SUBJECT: **Conditional Use Permit, Site Plan Review, Adjustment Driveway Approach Permit and Design Review Case No. CU-SPR-DAP-DR21-05 – 4900 Block of State Street – 97301; Supplemental Staff Report**

On January 24, 2022, the applicant submitted an updated site plan (Sheet SDR3) and building elevation plans (**Attachment A**). On January 26, 2022 the applicant submitted an updated written response. The following is a staff response to the applicant's updated plans and findings (**Attachment B**).

EAST PARK APARTMENTS

BUILDING ELEVATIONS

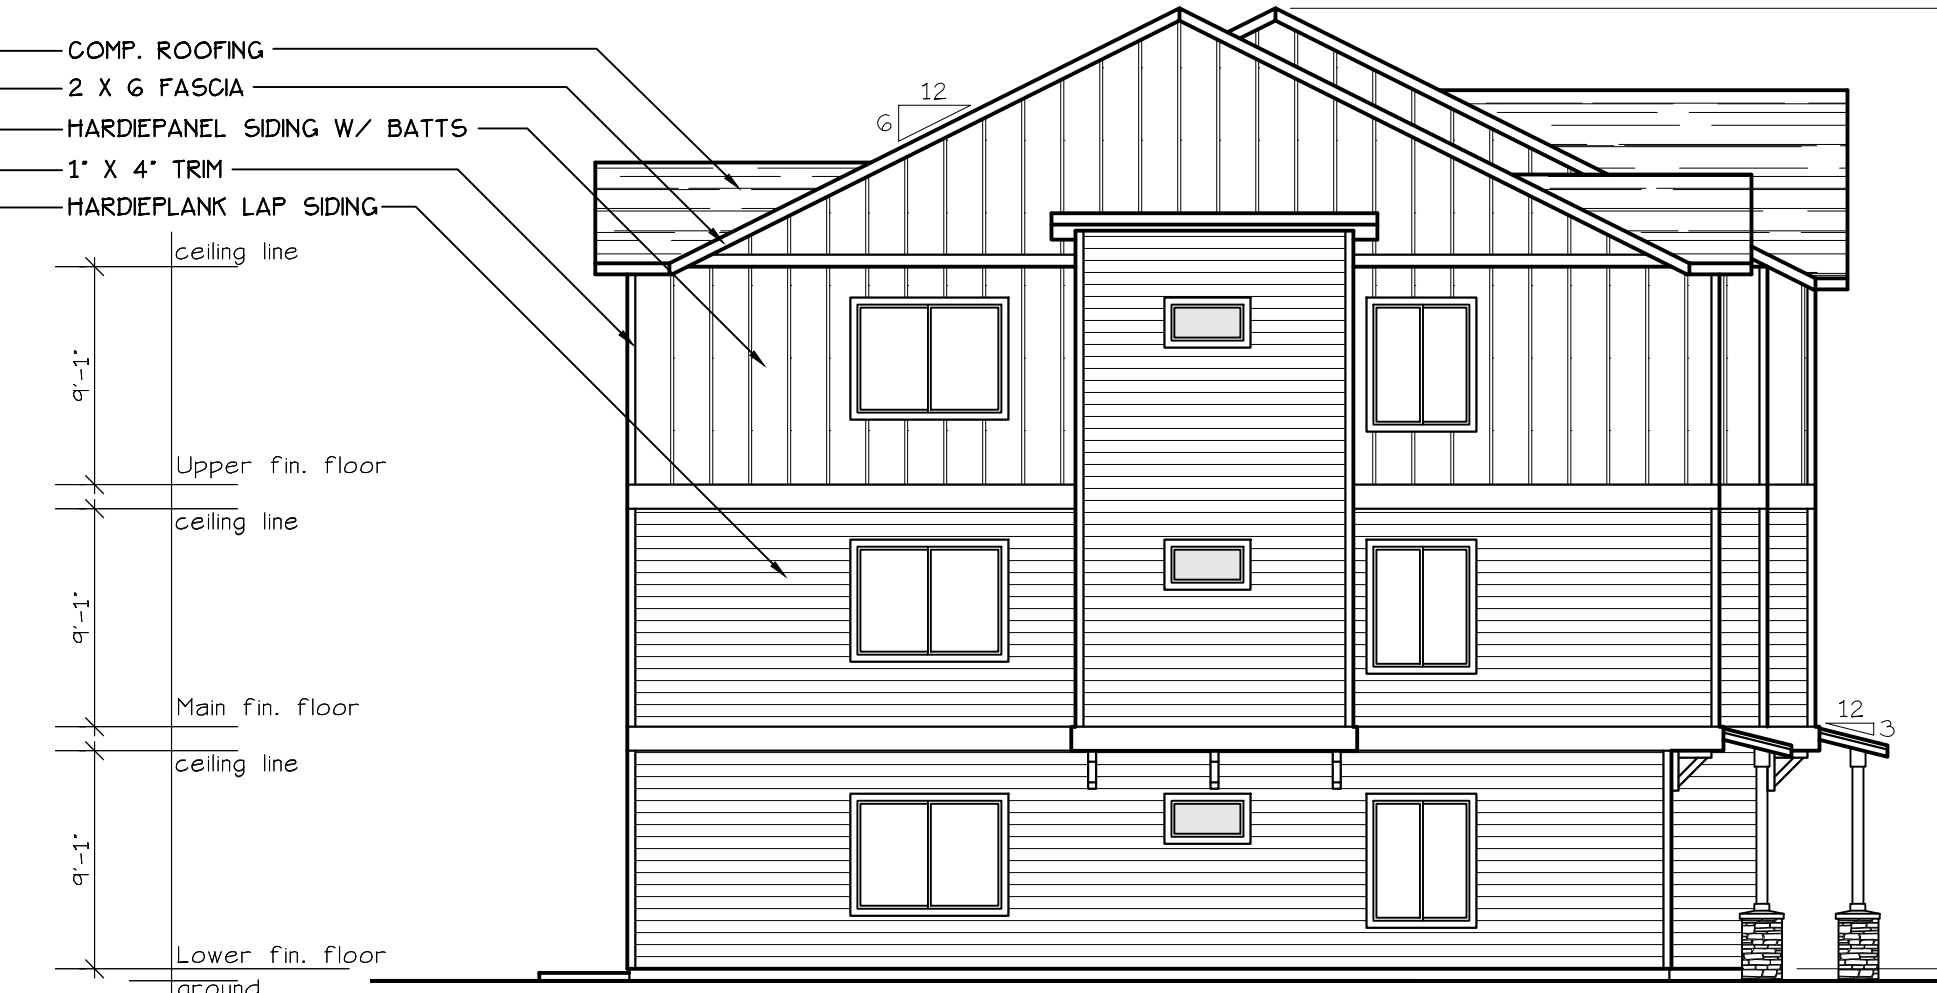
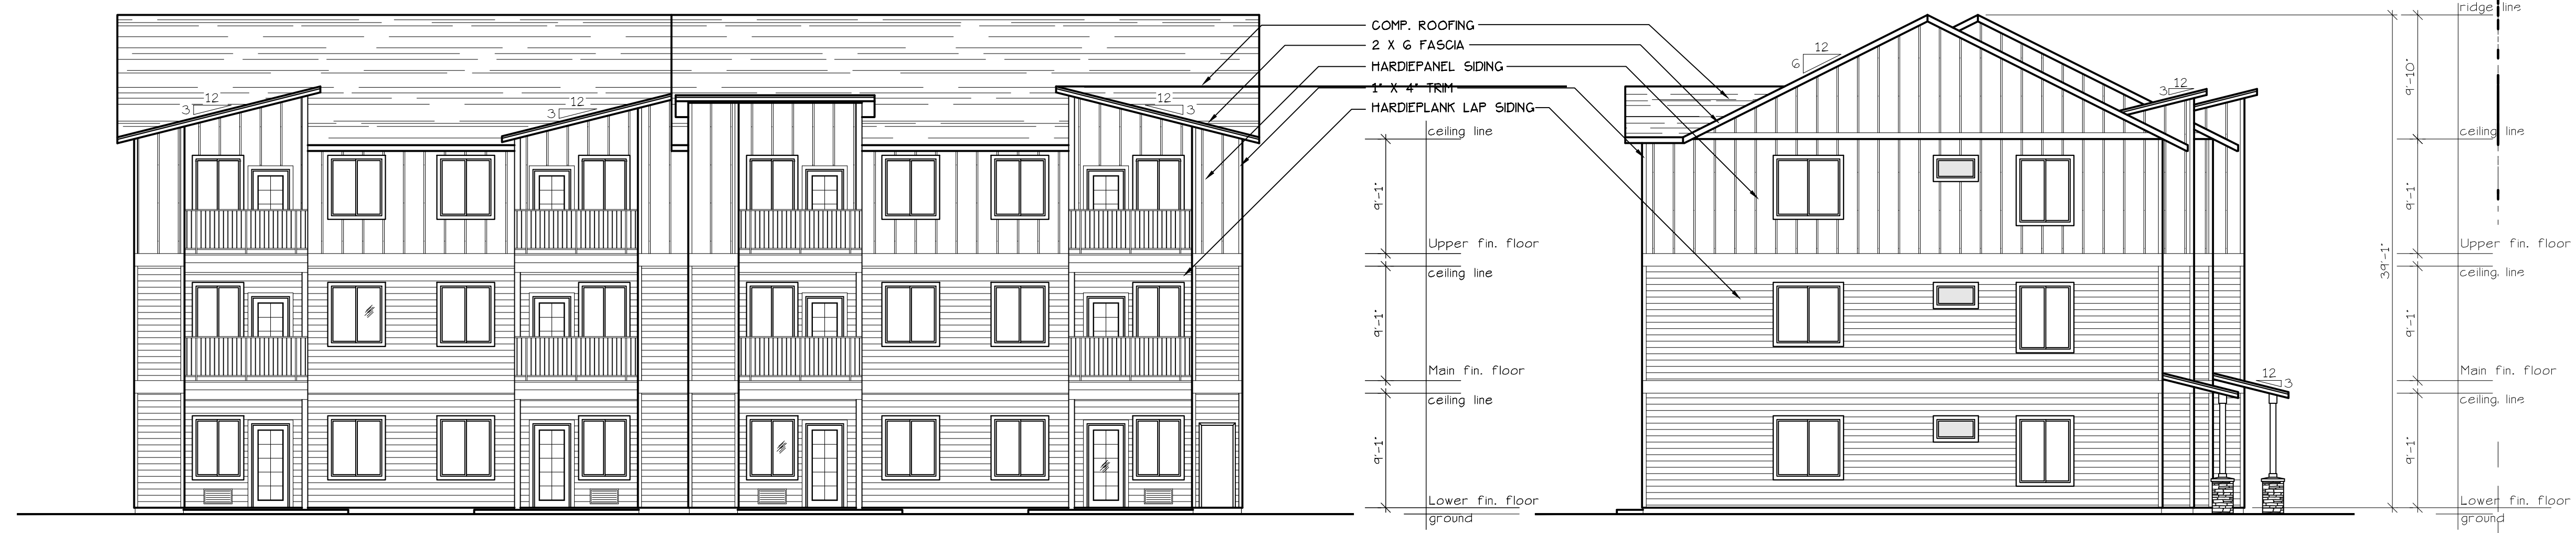
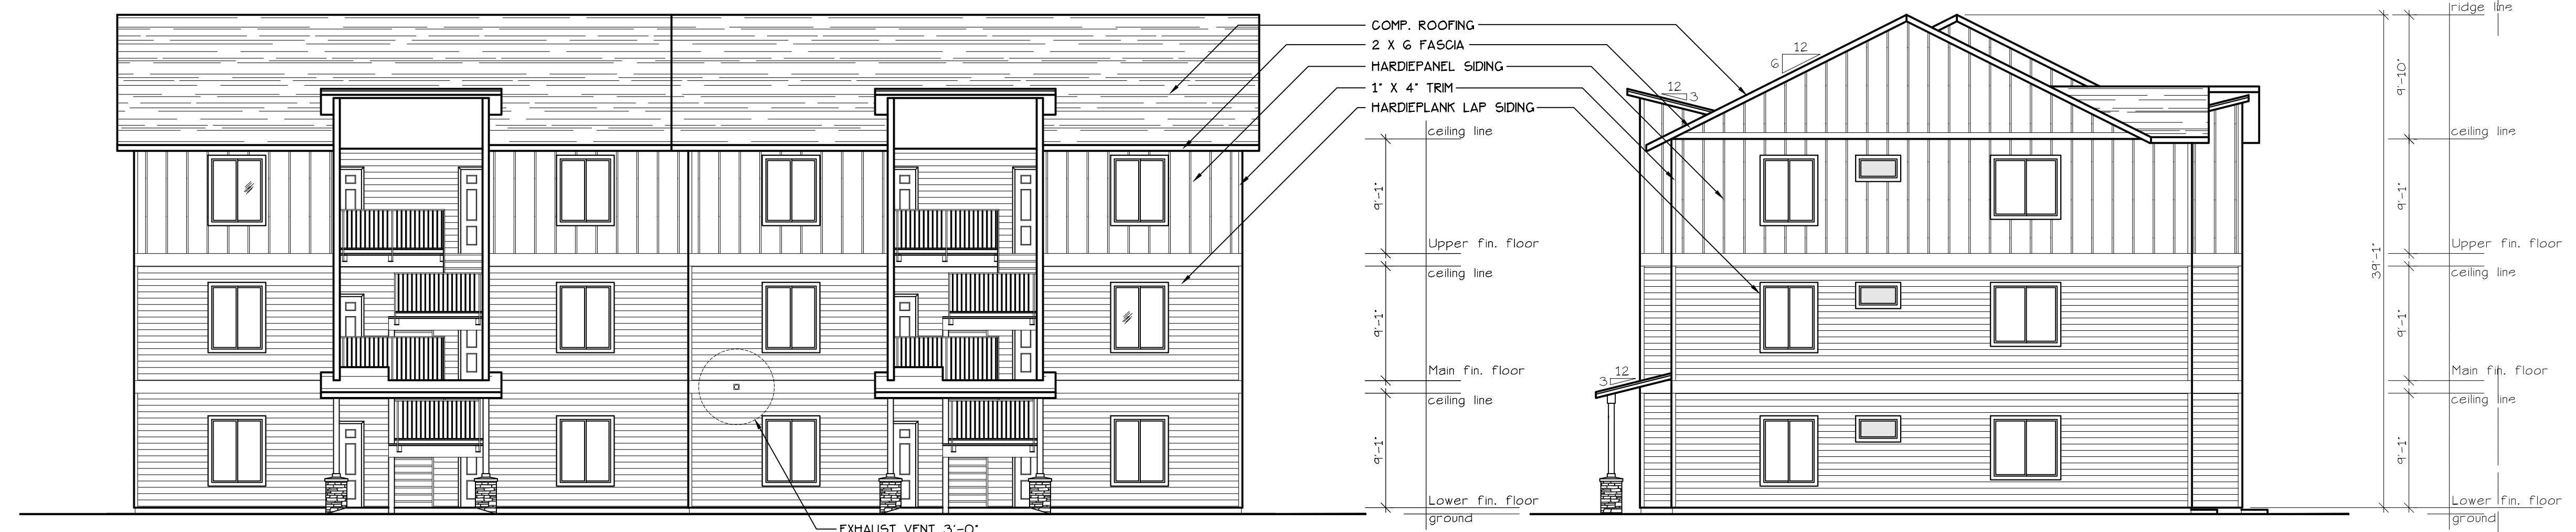
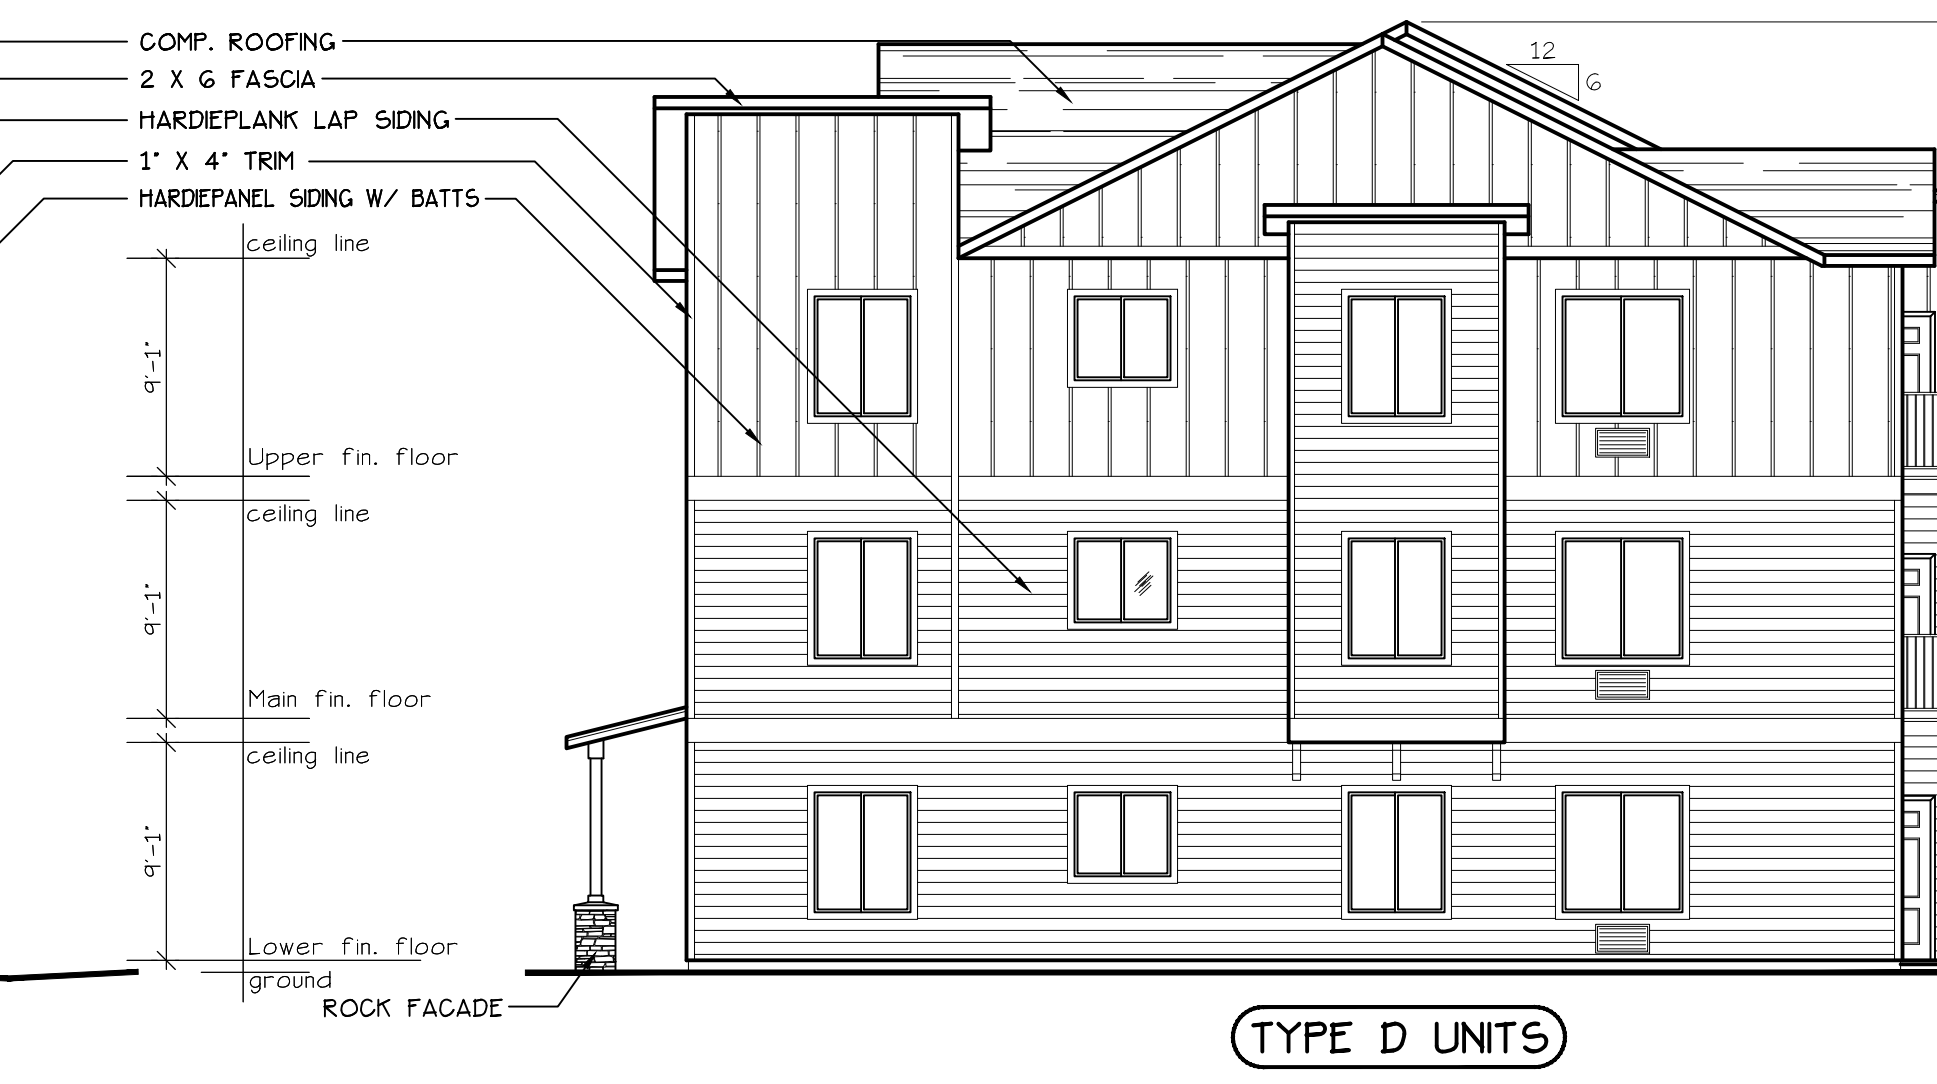
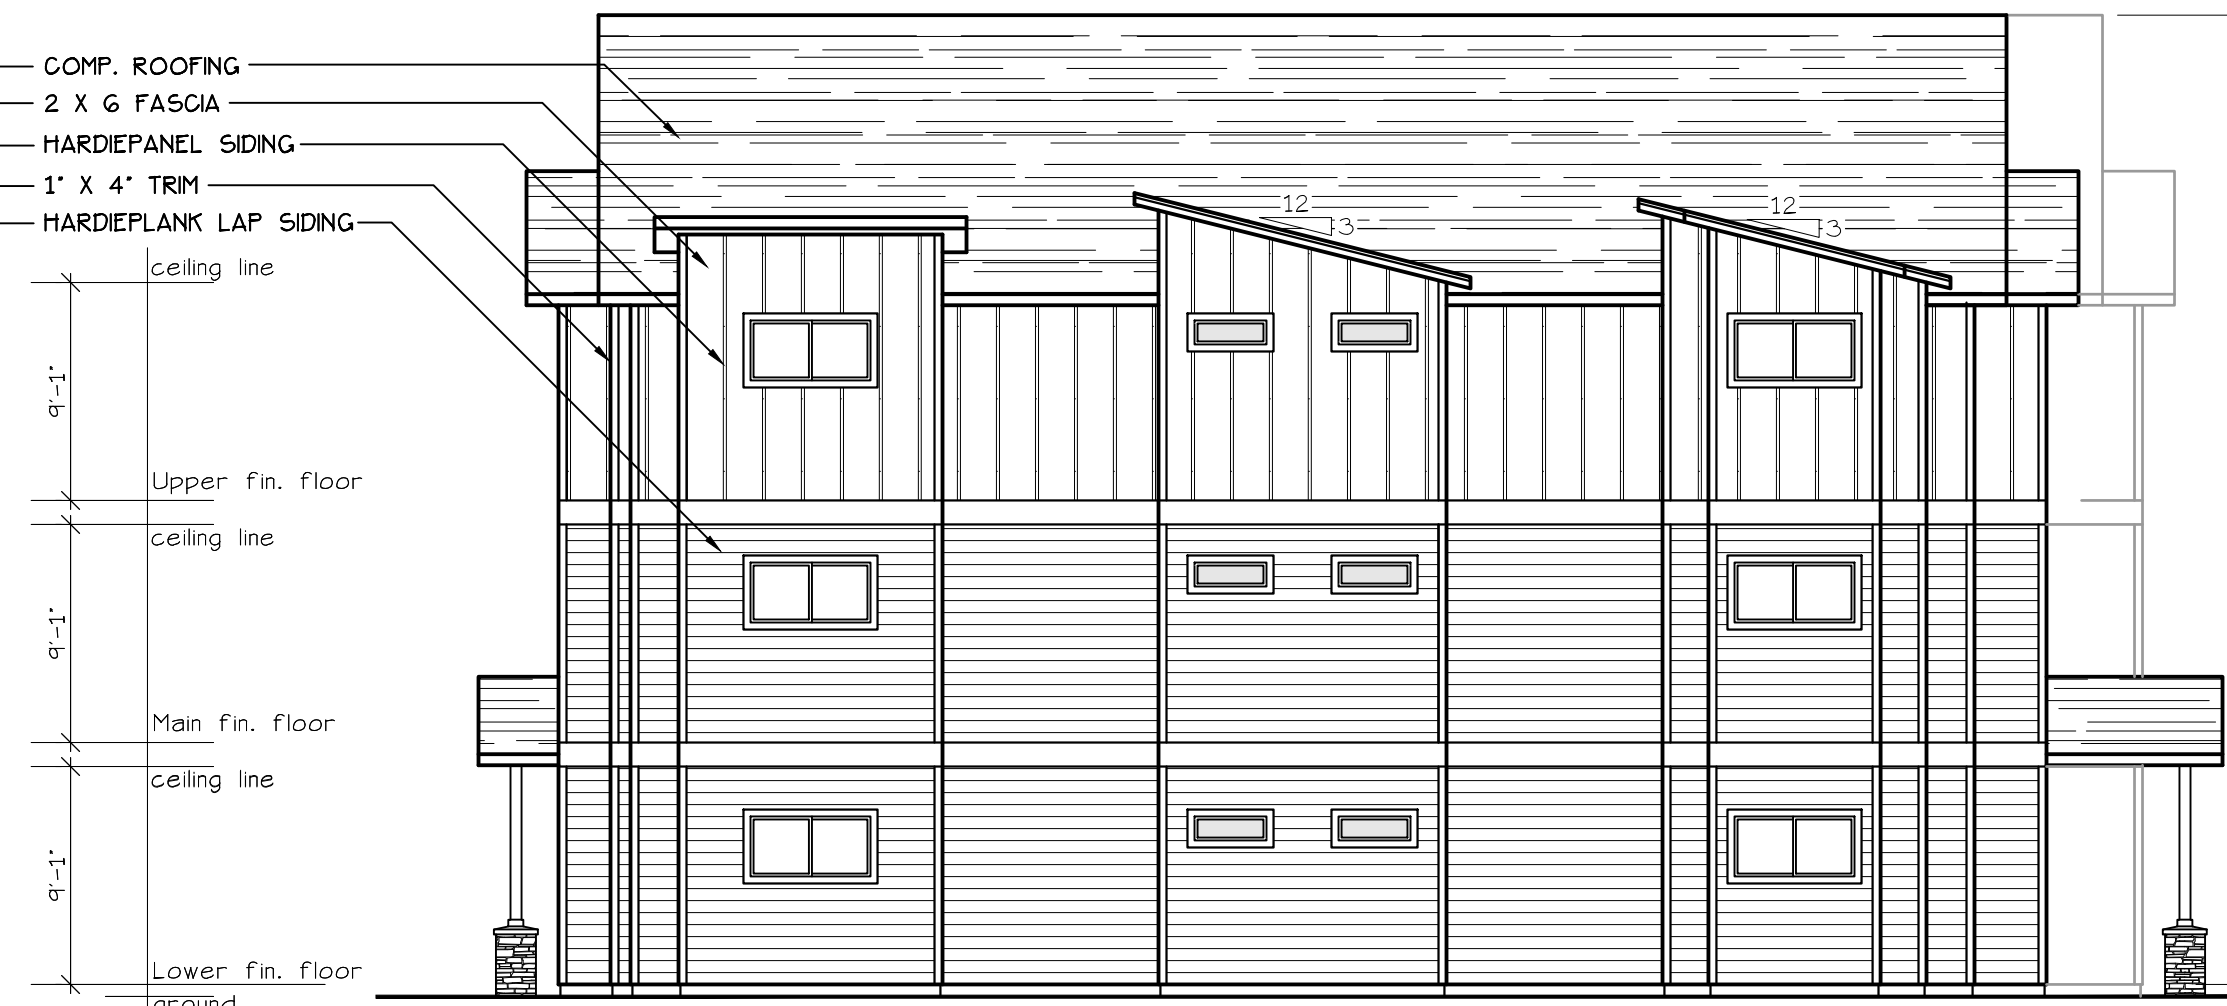
- d. Additional window area.

The building plans and elevations provided for the December 22, 2021 hearing showed that windows were not provided in habitable rooms at the end elevations for proposed buildings 1-8, 10, 14-20, 22, 25 and 27 which is not in compliance with the multi-family design standards for site safety and security. The applicant's update building plans identify additional windows provided in habitable rooms in compliance with the multi-family design standards, staff has no further concerns.

This provision requires windows on each wall in habitable rooms that face common open space, parking areas, and pedestrian paths. Previously, the habitable rooms at the end elevations for Buildings 1-8, 10, 14-20, 22, 25, and 27 did not include windows. The revised elevations are enclosed, and demonstrate this standard is met.
